AGENDA
MEETING OF THE
HIGHWOOD PLANNING AND ZONING COMMISSION

4.1 Petition for a Planned Unit Development from Allan Dennis, of Midwest Young Artists (MYA). The petitioner has applied to permit the use of vacant land, parcel #16-10-401-014 in Highwood IL, 60040 to be used as a concert hall and musical campus.

Subject: Resubmittal of Request for Zoning Change

Subject: MYA Campus Expansion
Conceptual Plan #2
(CBBEL Project No. 170196.R2301)

1: Sheridan Road & Sheridan Plaza North Access Drive

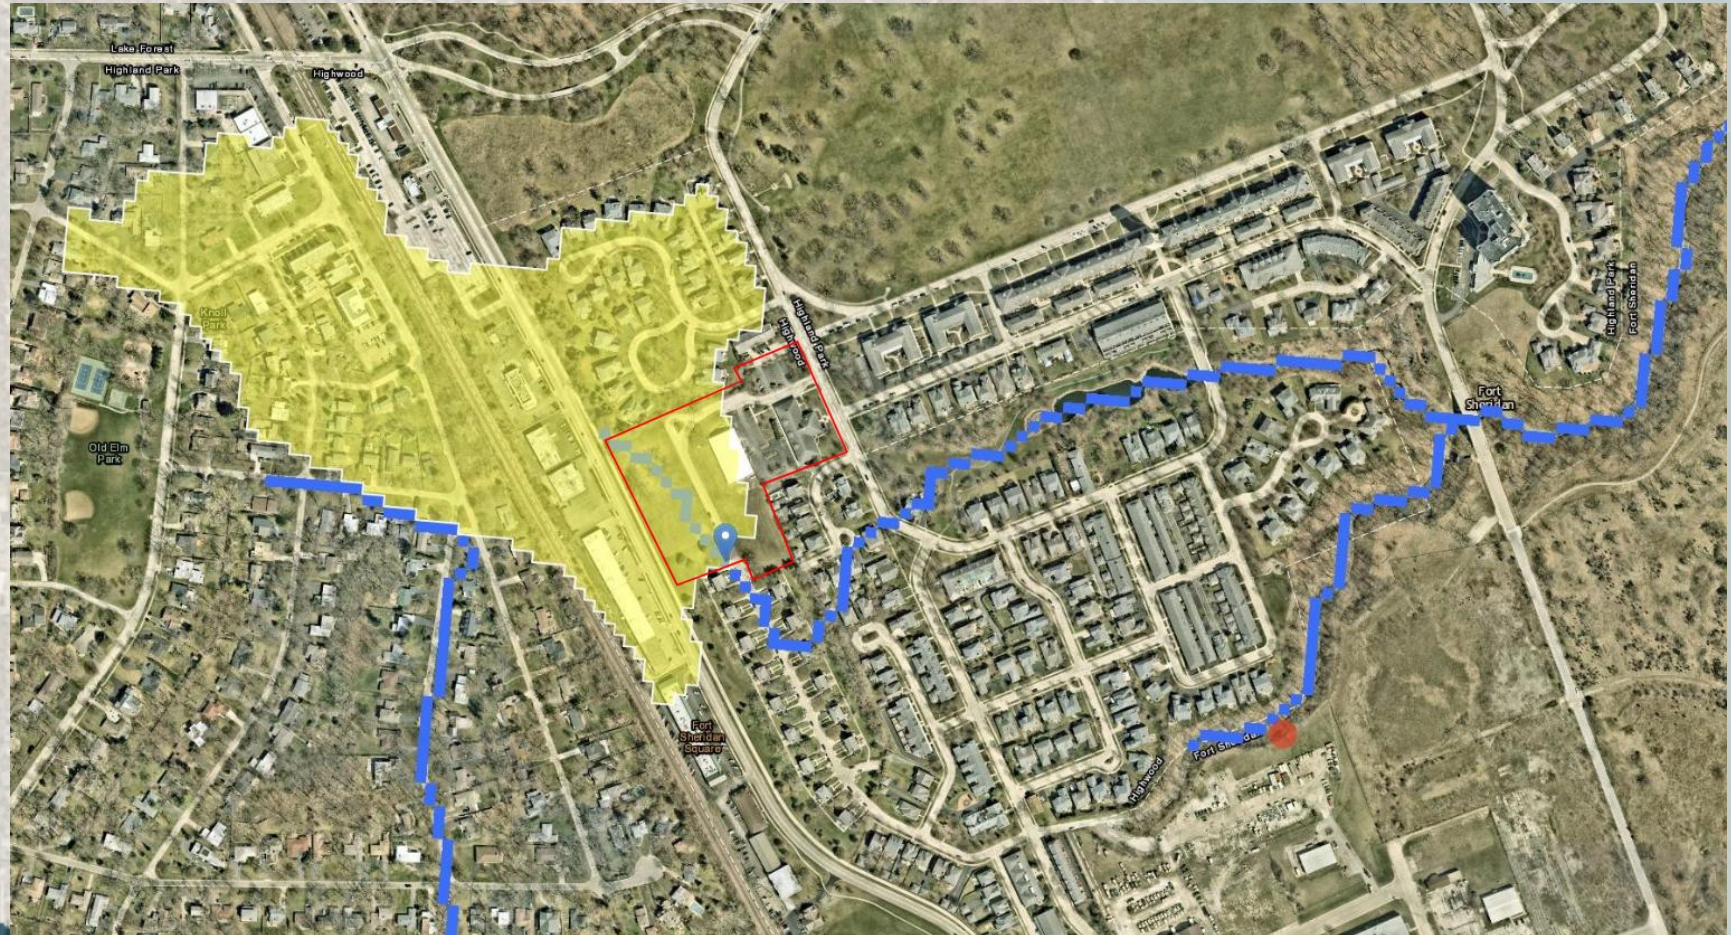
Intersection						
Int Delay, s/veh	0.3					
Movement	EBL	EBR	NBL	NBT	SBT	SBR
Lane Configurations						
Traffic Vol, veh/h	7	10	0	392	400	2
Future Vol, veh/h	7	10	0	392	400	2
Conflicting Peds, #/hr	0	0	0	0	0	0
Sign Control	Stop	Stop	Free	Free	Free	Free
RT Channelized	-	None	-	None	-	None
Storage Length	0	0	-	-	-	-
Veh in Median Storage, #	0	-	-	0	0	-
Grade, %	0	-	-	0	0	-
Peak Hour Factor	89	89	89	89	89	89
Heavy Vehicles, %	0	0	0	0	0	0
Mvmt Flow	8	11	0	440	449	2
Major/Minor	Minor2	Major1		Major2		
Conflicting Flow All	890	450	451	0	-	0
Stage 1	450	-	-	-	-	-
Stage 2	440	-	-	-	-	-
Critical Hdwy	6.4	6.2	4.1	-	-	-
Critical Hdwy Stg 1	5.4	-	-	-	-	-
Critical Hdwy Stg 2	5.4	-	-	-	-	-
Follow-up Hdwy	3.5	3.3	2.2	-	-	-
Pot Cap-1 Maneuver	316	613	1120	-	-	-
Stage 1	647	-	-	-	-	-
Stage 2	653	-	-	-	-	-
Platoon blocked, %				-	-	-
Mov Cap-1 Maneuver	316	613	1120	-	-	-
Mov Cap-2 Maneuver	316	-	-	-	-	-
Stage 1	647	-	-	-	-	-
Stage 2	653	-	-	-	-	-

Traffic Vol, veh/h 0 0 7 392 399 11

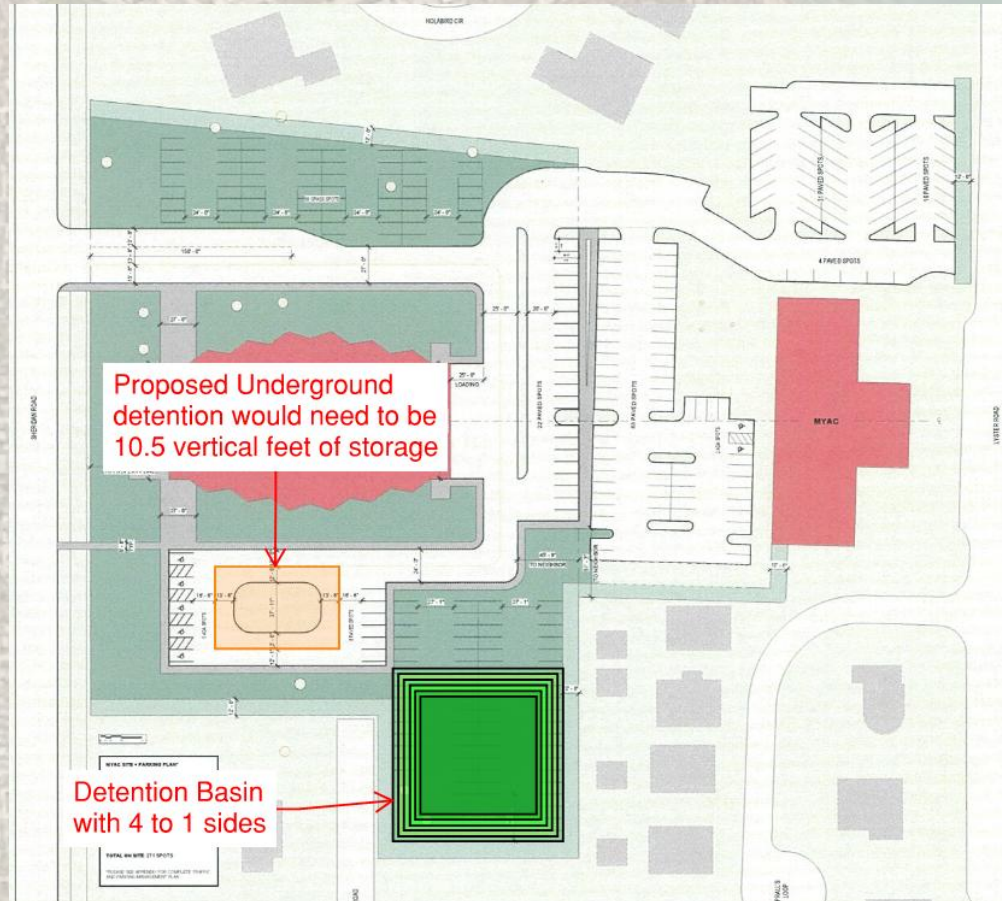
Conflicting Peds, #/hr 0 0 0 0 0 0

Sign Control Stop Stop Free Free Free Free

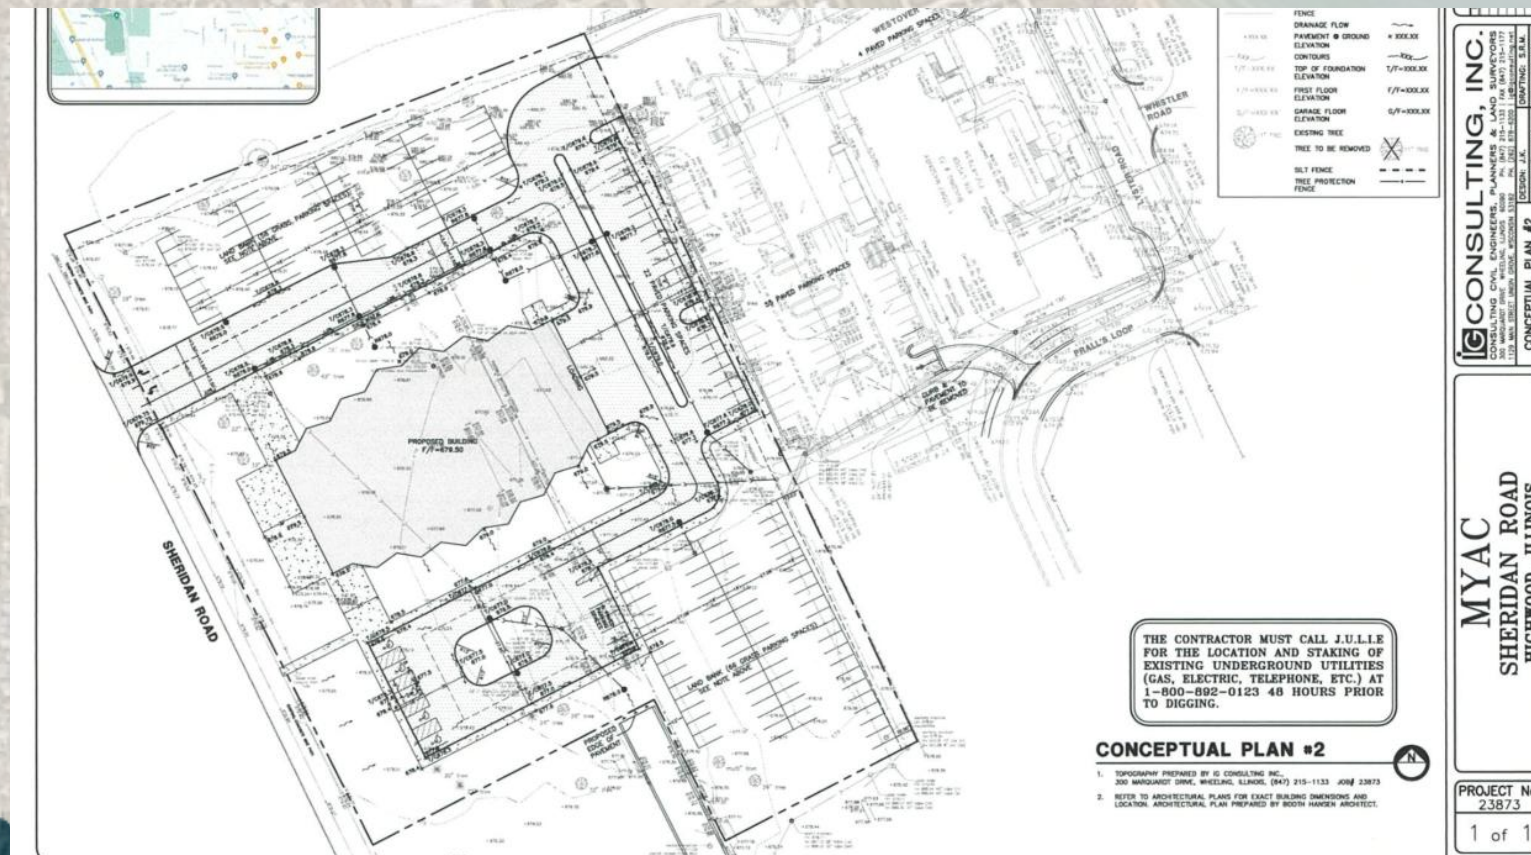
RT Channelized - None - None - None

Veh in Median Storage, # 0 - - 0 0 -

Grade, % 0 - - 0 0 -

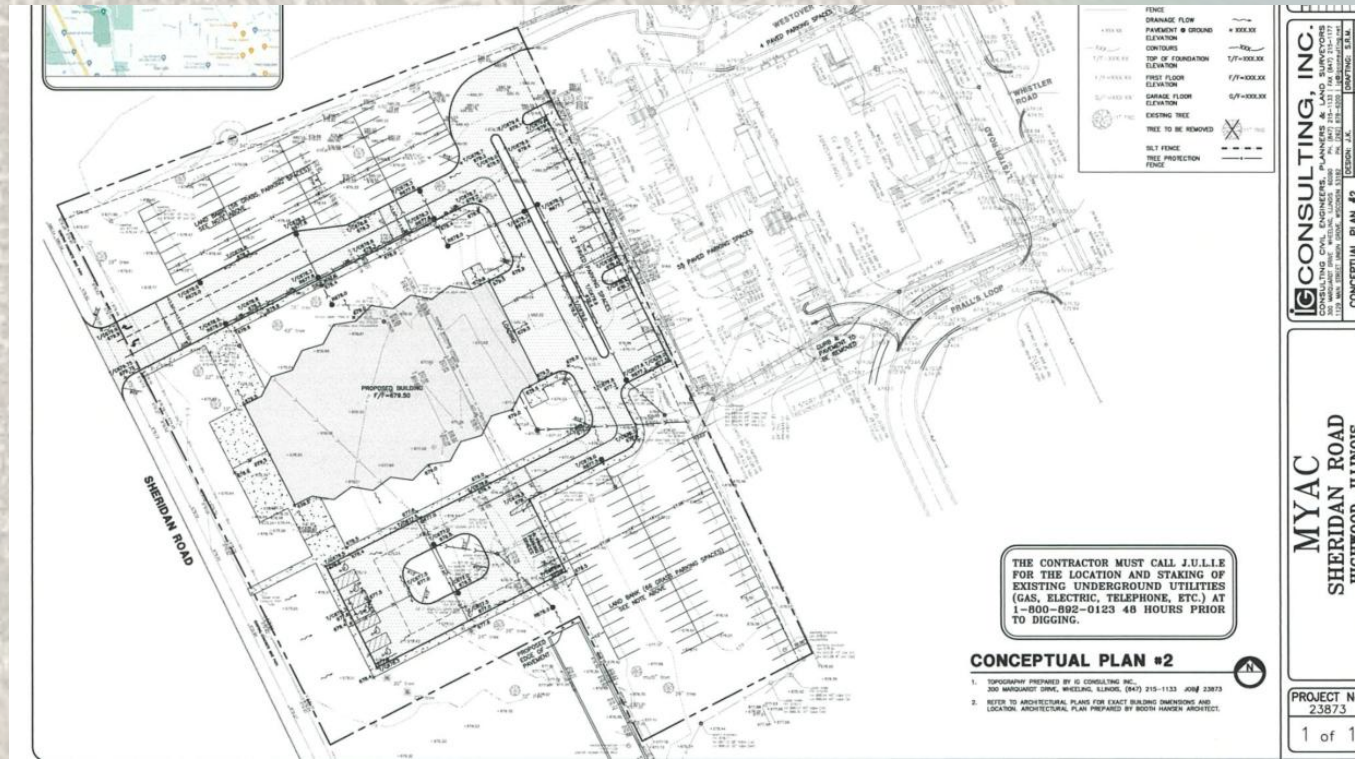
Heavy Vehicles, % 0 0 0 0 0 0
